7 MR. McKELVEY: My name is Terry McKelvey. I am  
8 the principal electrical engineer involved in the design of  
9 Fermi 2. And I am going to present to you the reliability  
10 of our station power, including the effects of the loss of  
11 various stages of AC and DC, and get into the discussion on  
12 station blackout.

13 In order to do that, I would like to give you a  
14 feeling for the diversity of our offsite power source.

FIG 1 ENRICO FERMI 2 OFFSITE POWER SOURCES

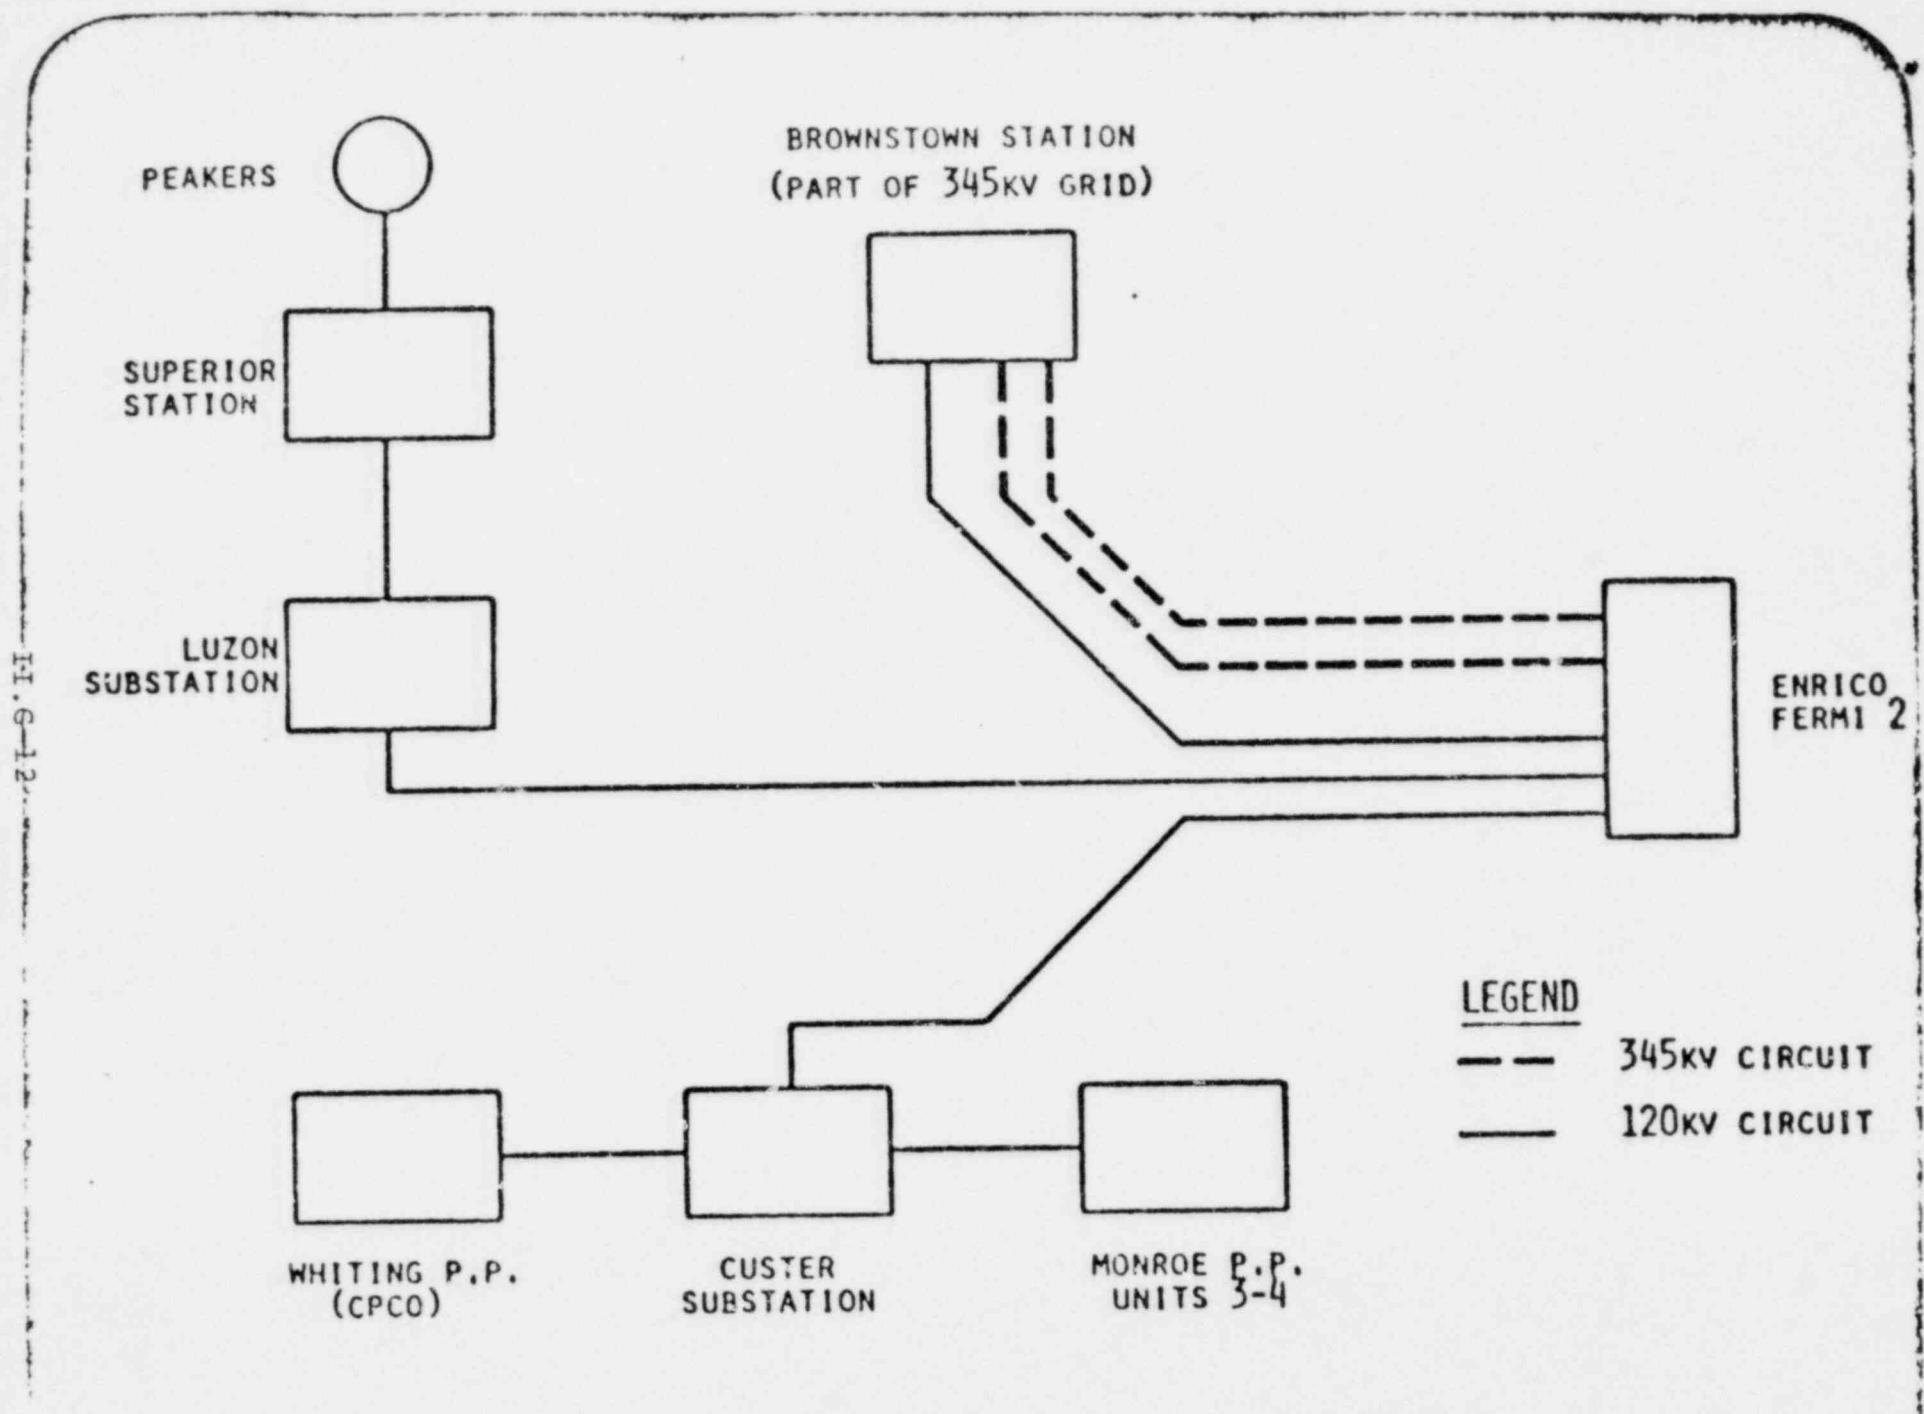
4 MR. CARBON: How widely separated are the five  
5 lines coming into the plant?

18 MR. RAY: When you say they are designed -- the  
19 falling tower will not impact an adjacent line?

2 MR. RAY: You have not answered the question, but  
3 you have given me an implied answer. I gather from what you  
4 say that if the EHF line went down it would take down one of  
5 the 120-kV lines, is that what you are saying?

17 MR. RAY: Are you saying, then, that if one of the  
18 345-kV lines failed it would take out three 12-kV lines with  
19 it? It would take out three 120's? So a falling tower on  
20 the high line could leave you with one line.

23 MR. RAY: Is the system stable under these  
24 conditions?

6 MR. McKELVEY: Okay. There is a common  
7 transmission corridor into Fermi 2 for approximately five  
8 miles. That is as shown here (Indicating). The line -- the  
9 corridor is 500 feet wide. It has been designed to take the  
10 worst failure of any structure falling over that would leave  
11 enough lines -- all we need out of these five lines is one  
12 separate line existing to power adequate ESF at Fermi 2.

13 So we have designed the spacing of the  
14 transmission lines on this common corridor to accommodate  
15 the falling over of a 345-kV tower.

20 MR. McKELVEY: There are five separate lines. The  
21 345-kV towers are on the outside of the 500-foot right of  
22 way. In the center are the three 120kV lines. Obviously,  
23 the largest structure is the 345-kV tower and if one of  
24 those lines fell over across the other transmission lines we  
25 would still have adequate transmission lines available to

8 MR. McKELVEY: It might take a couple lines down.  
9 We would have at least one transmission line available to  
10 the site.

25 MR. McKELVEY: Yes. The system has been analyzed

18          MR. COLBERT: Characteristically, all of our  
19 studies take into account all kinds of faults, that is  
20 three-phased faults, double phase to ground and single-phase  
21 faults. And we would take into account the various loss of  
22 generators under certain conditions with a reduced  
23 transmission system, and then see if the system remains  
24 stable and if the generators go out of step.

FIG. 2 ENRICO FERMI 1 120KV SWITCHYARD

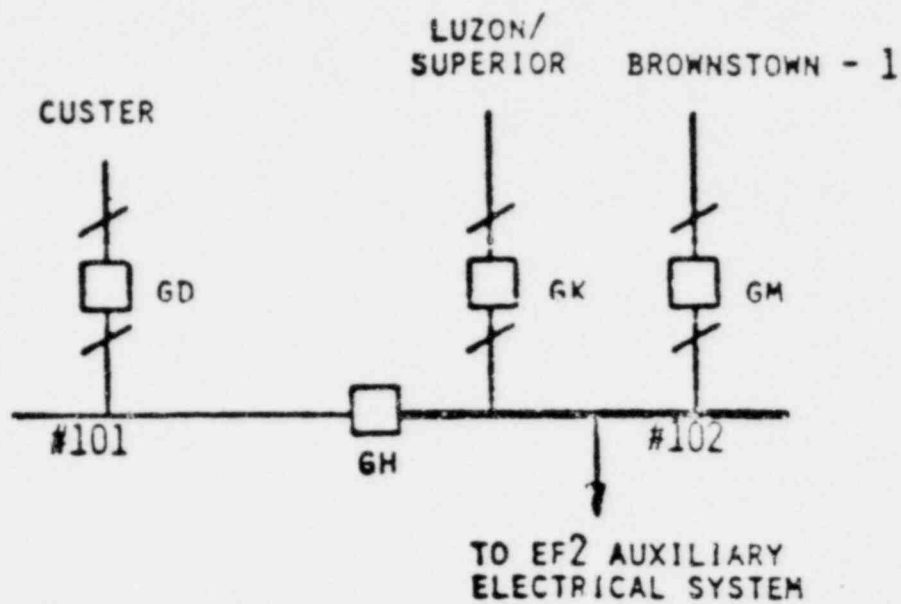
18           MR. RAY: Is that bottom feed to the right that  
19 goes downward -- I cannot read it. The 120-kV, is that the  
20 point of connection of these other units that are on the  
21 Fermi site?

22           MR. McKELVEY: Right. The next slide will show  
23 that. Note that this is bus 102.

FIG. 4 ENRICO FERMI 2 AUXILIARY ELECTRICAL SYSTEM

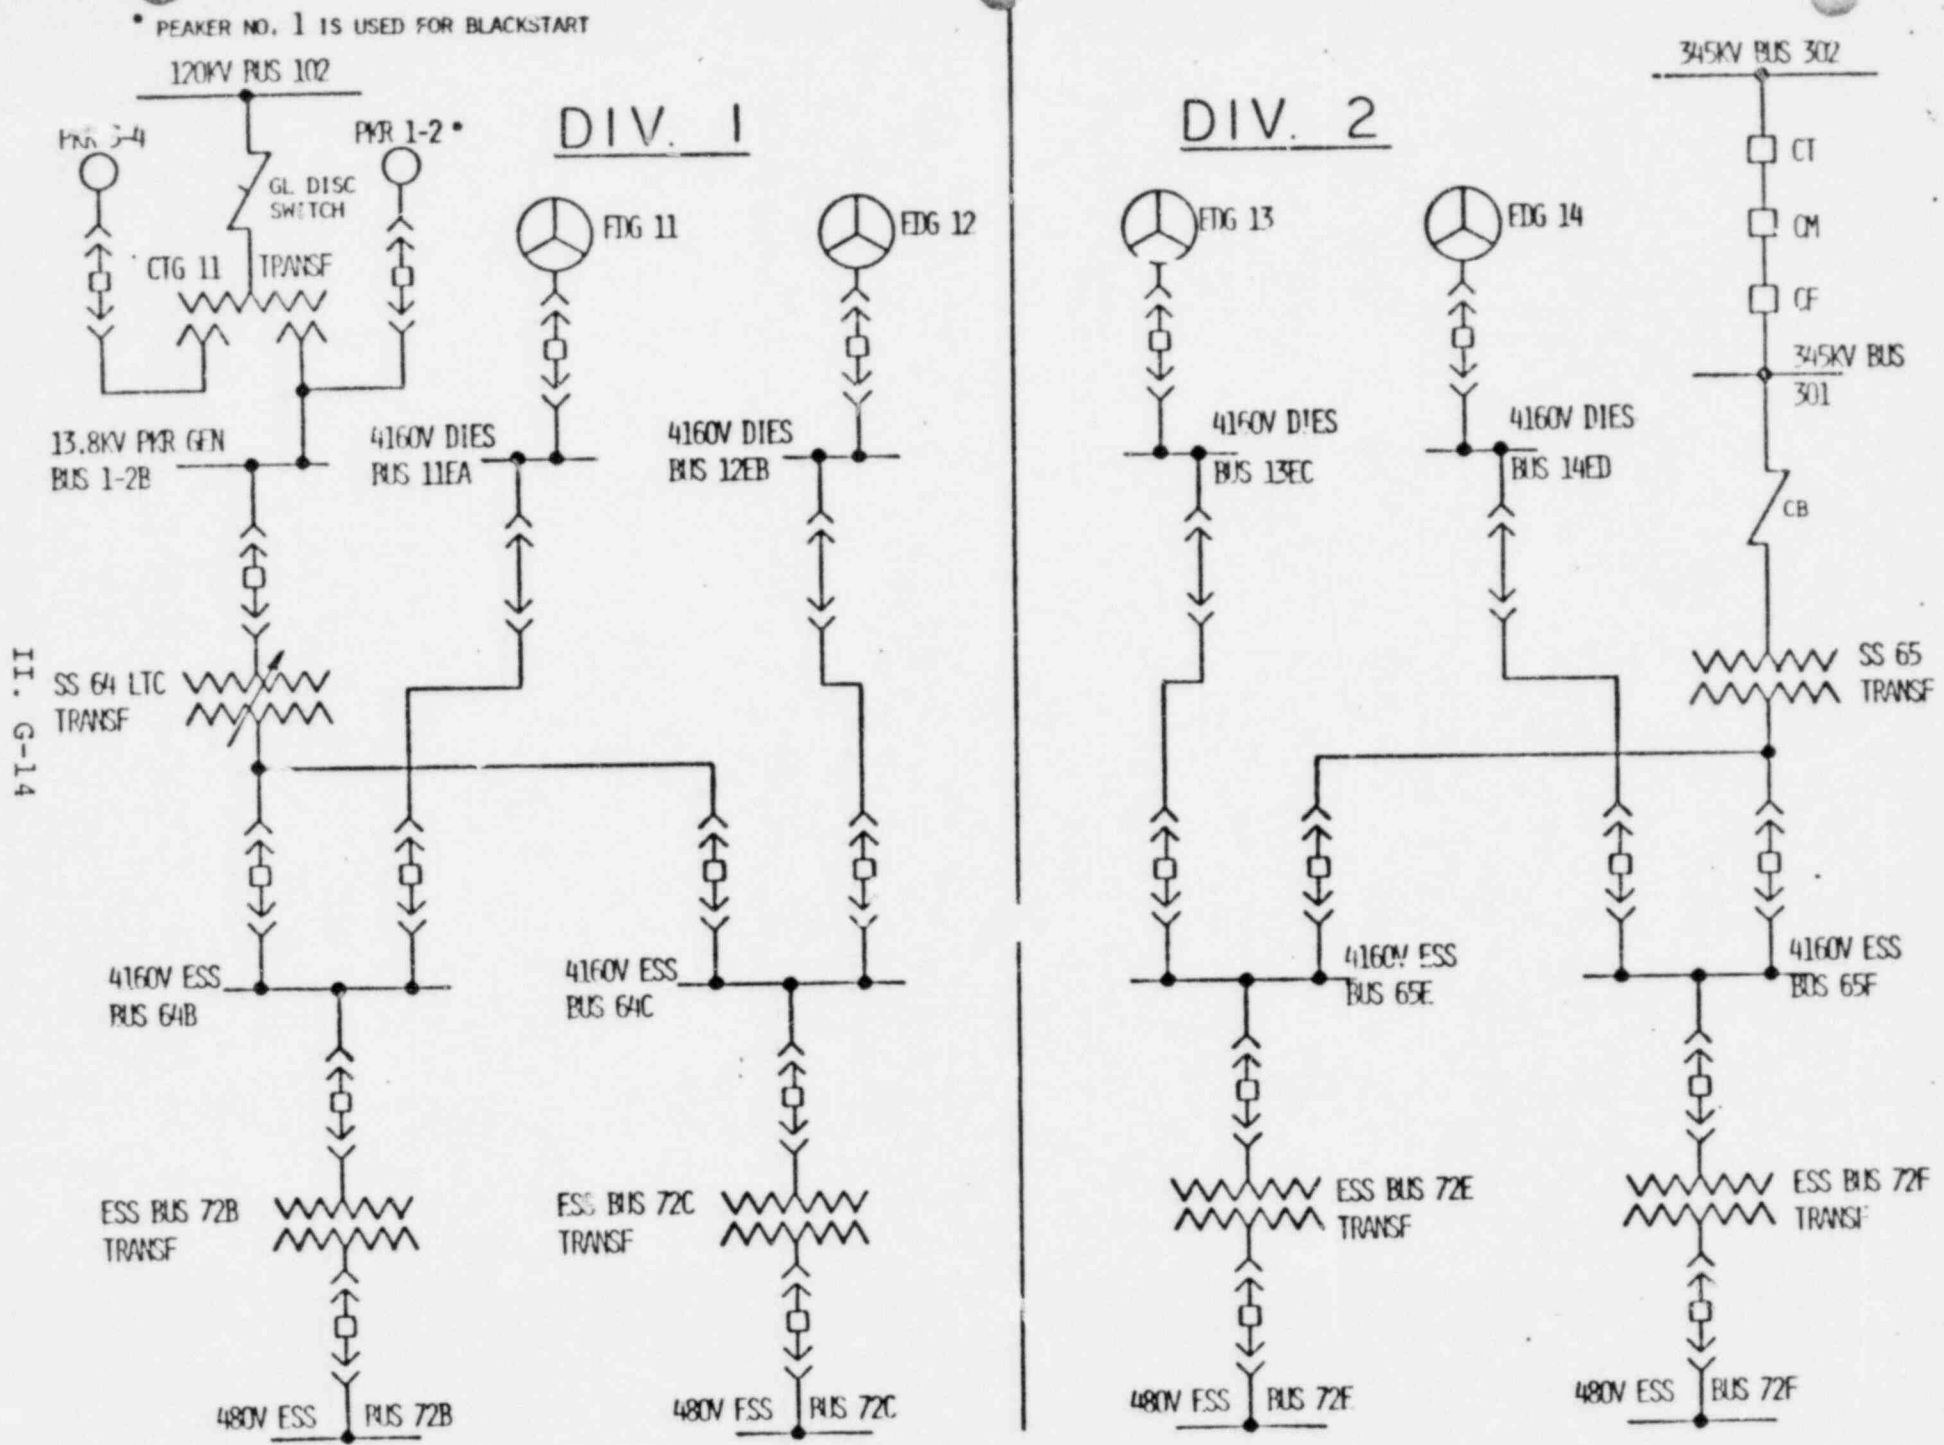
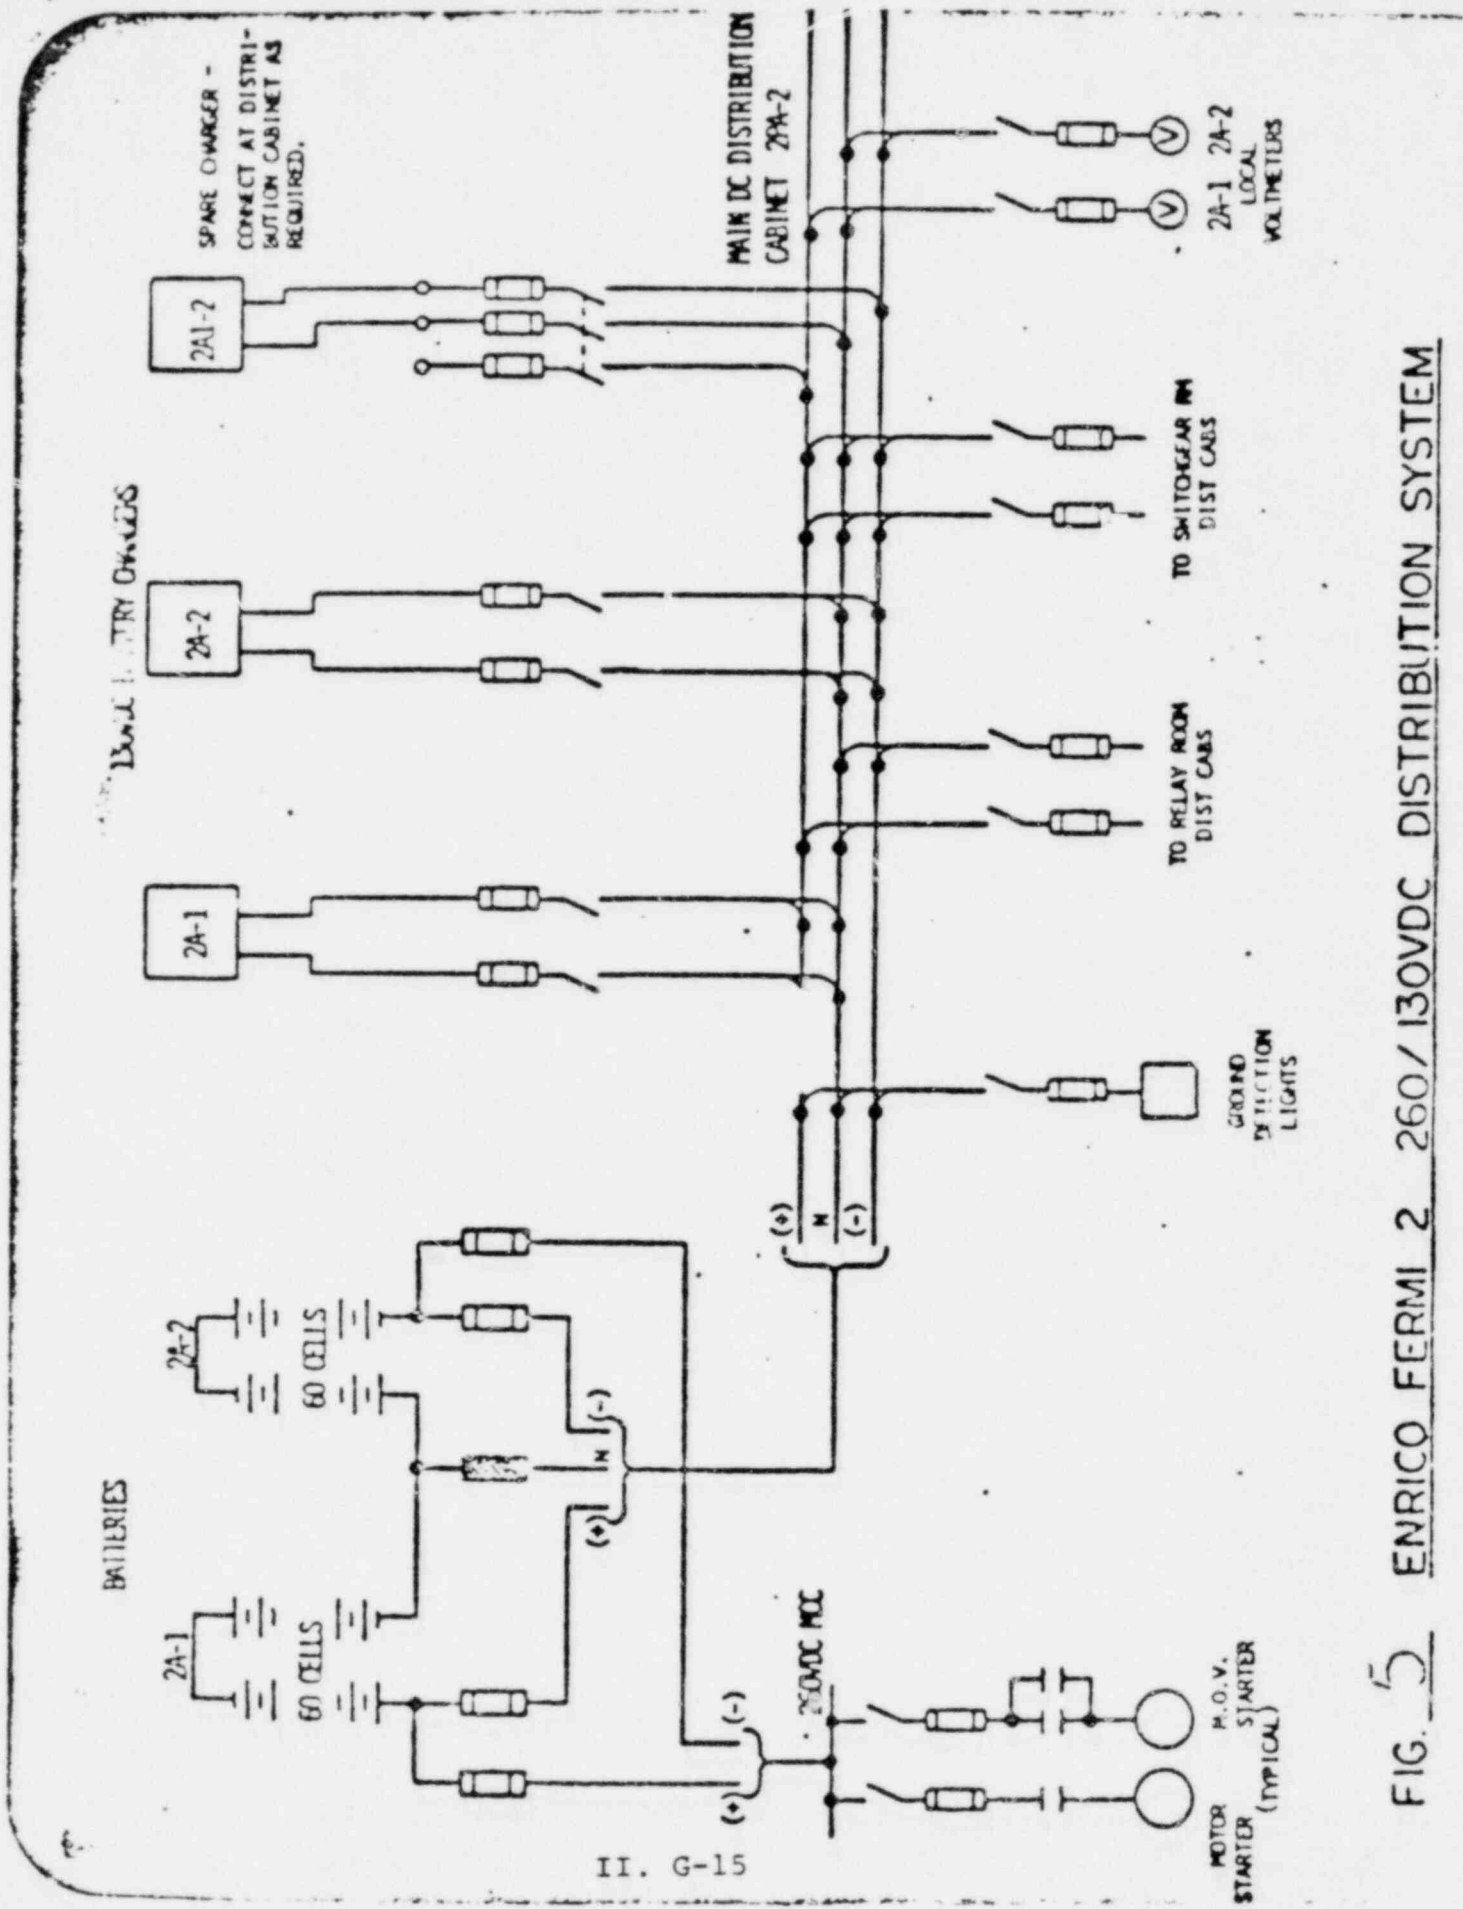
6 MR. RAY: Where is the 165 megawatt oil-fired unit  
7 connected?

8 MR. McKELVEY: It was tied to the other bus, bus  
9 101 in my previous slide.
